Location of Construction: 54 Warren Ave		Owner: Sal Raia		Phone: 773-9826		Permit No: <b>001296</b>	
Owner Address: SAA		Lessee/Buyer's Name: Robert Menard		Phone:		BusinessName:	
Contractor Name: SAA		Address:		Phone:		Permit Issued: NOV 14 2000	
Past Use:  vacant		Proposed Use:  Custom Blacksmith Shop  <i>low manufg use</i>		COST OF WORK: \$ 200.00		PERMIT FEE: \$ 30.00	
				FIRE DEPT. <input checked="" type="checkbox"/> Approved <input type="checkbox"/> Denied		INSPECTION: Use Group <i>1</i> / Type: <i>00C494</i>	
Proposed Project Description:  change of use from vacant to blacksmith shop will be installing a smoke stack to side of building. Has brought site plan exemption down stairs and will submit drawing fro stack Has already paid for permit.				Signature: <i>U Jim</i>		Signature: <i>[Signature]</i>	
				PEDESTRIAN ACTIVITIES DISTRICT (P.A.D.)		Zone: <i>4</i> CBL: 293-A-017	
				Action: Approved <input type="checkbox"/> Approved with Conditions: <input type="checkbox"/> Denied <input type="checkbox"/>		Zoning Approval: <i>OK with</i> Special Zone or Reviews: <input type="checkbox"/> Shoreland <i>computers</i> <input type="checkbox"/> Wetland <input type="checkbox"/> Flood Zo

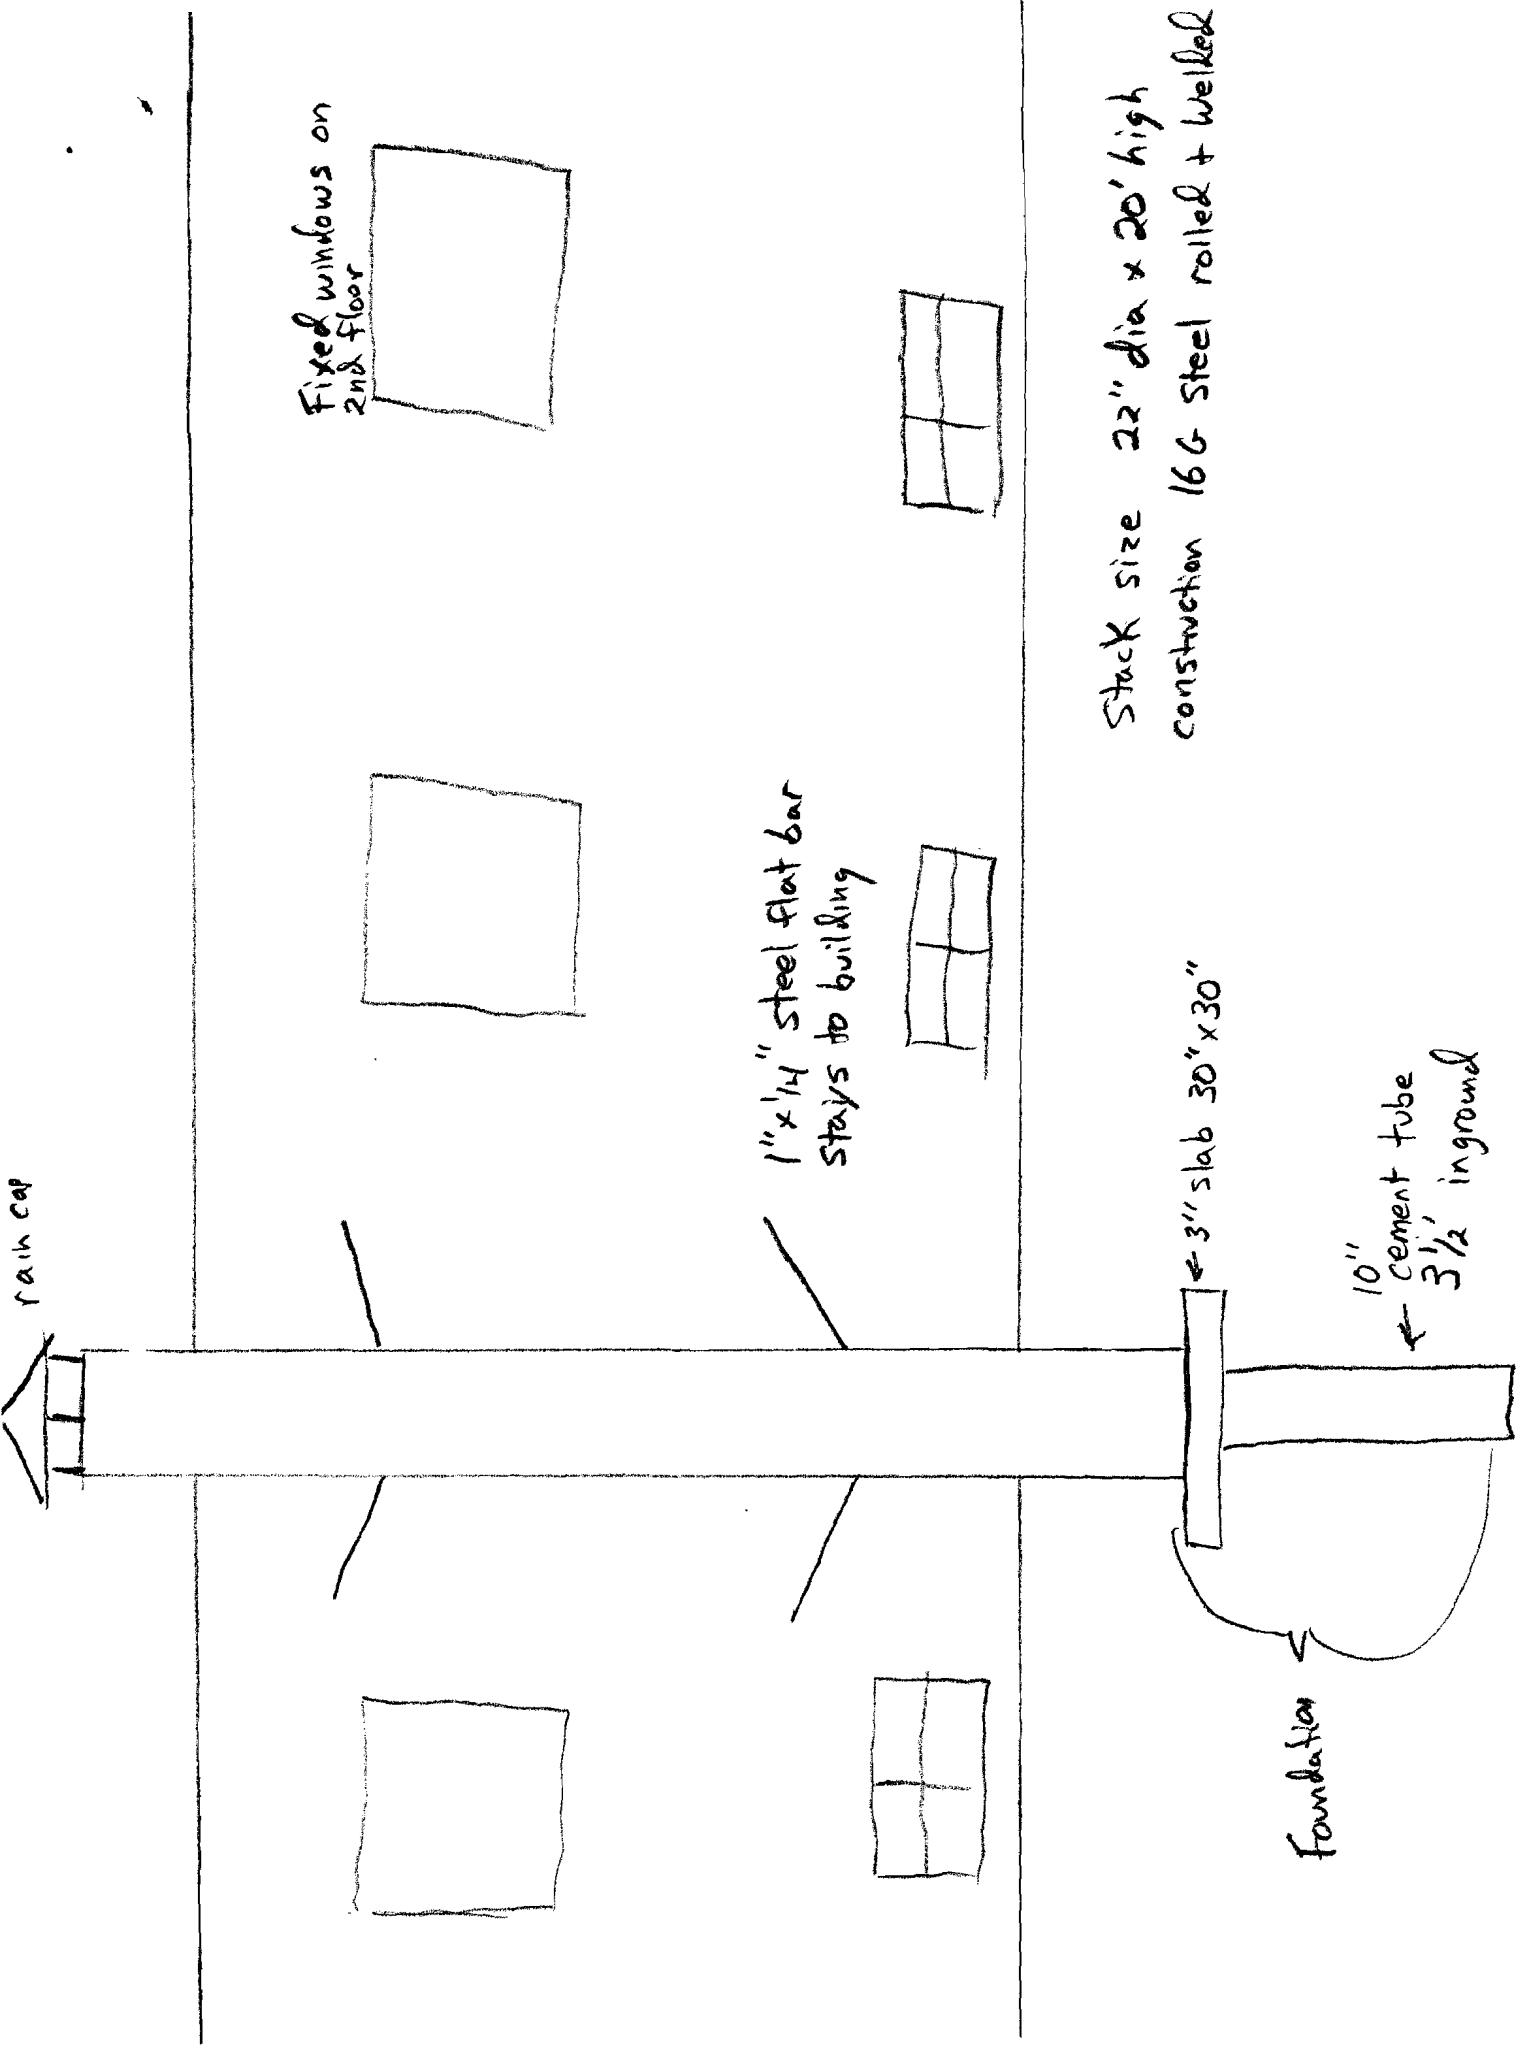
11-21-2K: Spoke w/ Bob Menard & requested plan of Stack be provided to go w/ Bldg Permit File of KW.

12-29-2K: Checked Stack - ? Height above roof referred to Lt. MacDougal All else appear to be ~~OK~~ ~~OK~~ Except that plan shows Stack 3' from Bldg. Act. Measurement = 2' from Bldg. SKW.

37. *Before work on stack is started submit a detail of how the proposed chimney is constructed and secured - foundation hanger etc.*
